Changing the side grid and the nuts

Models affected

Production until march März 2018 and until serial number TP182*

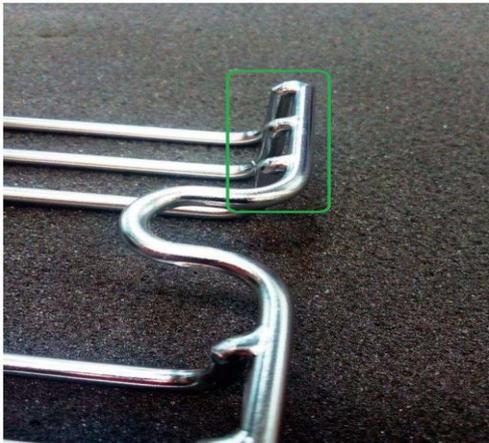
For the lateral grid inspection the following aspects must be confirmed by visual inspection:

OK: round edges

not OK: sharp edges

On appliances before TP182, the two side grids and the corresponding fixing nuts - if not already done - must be replaced.

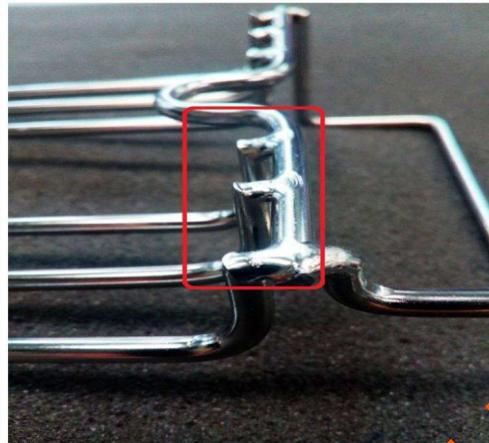
OK: flat surface in contact with the cavity

not OK: sharp projections

The side rails must be firmly screwed in with the lock nuts, otherwise they could damage and/or overheat.
